UNITED STATES PATENT AND TRADEMARK OFFICE

APPLICATION NO.	FILING DATE	FIRST NAMED INVENTOR	ATTORNEY DOCKET NO.	CONFIRMATION NO.
10/049,272	02/06/2002	Gabriel Daemon Engel	PURE-P002US	7736
41066 7590 08/14/2009 MURABITO, HAO & BARNES, LLP TWO NORTH MARKET STREET, THIRD FLOOR SAN JOSE, CA 95113				
EXAMINER				
NGUYEN, KEVIN M				
ART UNIT		PAPER NUMBER		
2629				
MAIL DATE		DELIVERY MODE		
08/14/2009		PAPER

Office Action Summary

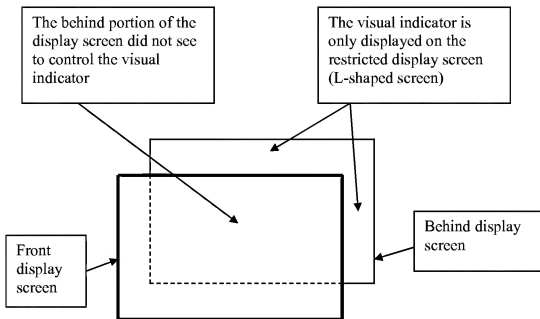
Claims 134-172 are rejected under 35 U.S.C. 101 because the claimed invention is not supported by either "said user-selectable input component is configured to move said visual indicator from a first display screen to a second display screen, [said first and second screens

overlap], in response to a first user interaction with said user-selectable input component” asserted utility or a well established utility.

The figure below, which is drawing by the claim 134, in which the claimed invention lacks patentable utility, where the only restricted display screen configured to move the visual indicator.
